Our Ref: 26007 RFI Response

**12 DAVIDSON STREET, PORT DOUGLAS
RFI RESPONSE- DUAL OCCUPANCY
OP 2026_5967/1, LOT 706 PTD PLN 2092**

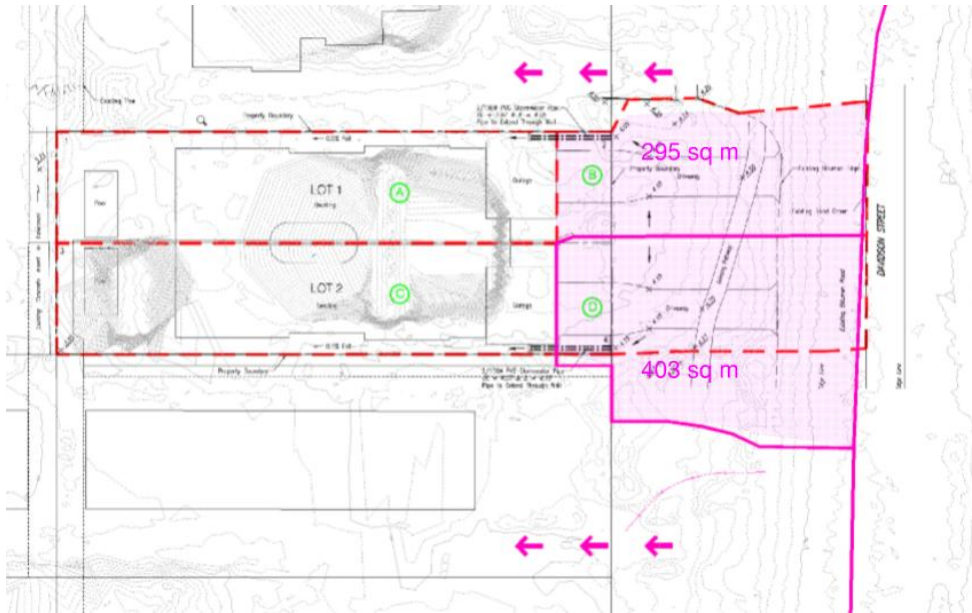
Provide catchment boundaries and hydrology calculation to confirm peak runoff at the critical points of interest for the internal and external catchments. Based on this information, provide hydraulic calculations for the drainage elements to demonstrate the drainage corridors and drainage profiles proposed have capacity for conveyance of flows without impacting adjacent properties.

Current LiDAR and site inspections were used to determine the catchments to each driveway. It should be noted that the catchments are small in nature and generally cover the allotment frontage to the road crown directly in front of each duplexes garage.

A sketch of these catchments is shown below:

As flow paths and piped drainage down both side boundaries are the same, flow calculations have been based on the larger of the 2 catchments whilst assuming the Q100 piped drainage line is 100% blocked – which is considered highly unlikely.

Calculations are attached and confirms overland flow depths down the sides of the duplexes are minimal and will not flood the duplexes or enter the garages in a 1%AEP event.
